**PCN#20180327000**  
**Conversion to smaller reel (13" to 7") and associated packing materials**  
**on Select Devices currently shipped in 13" reels**  
**Final Change Notification**

**20180327000**  
**Attachment: 1**

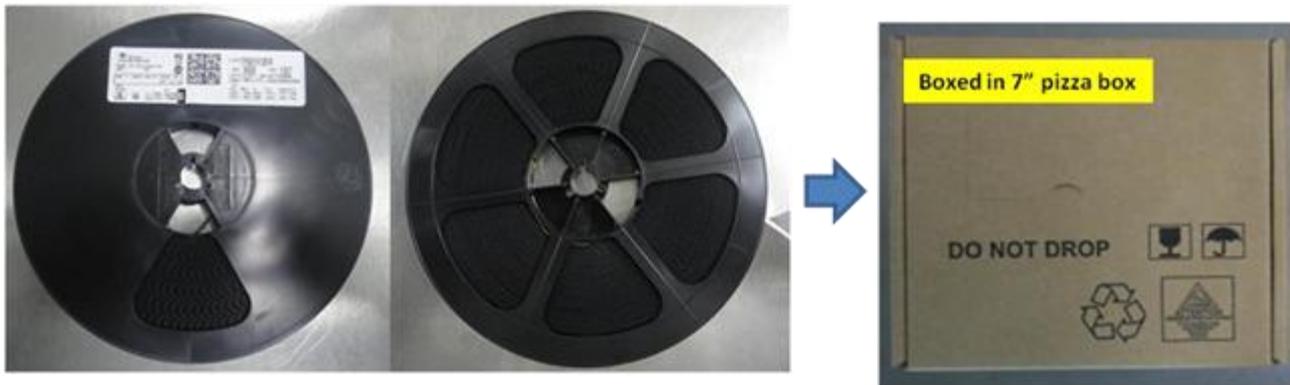
Conversion to a smaller reel size for selected product currently shipped in 13" reels with small reel quantities. The Moisture Barrier Bag (MBB) and pizza box will be switched to accommodate the smaller reel size. All new packing materials are qualified and currently in use for other products. Pack material differences are shown below:

Current Packing – 13 inch reel diameter

Proposed Packing – 7 inch reel diameter

Quality improvement. There has been reported quality issues with reels shipped with less than half full of product causing reel deformation.

Pack BOM	From	To
Reel Diameter	13"/4220831	7"/4203839
Pizza Box	4207162	4206831
Pack Filler	4208630	4221303

Product will be shipped in smaller (7") Reels and packing materials
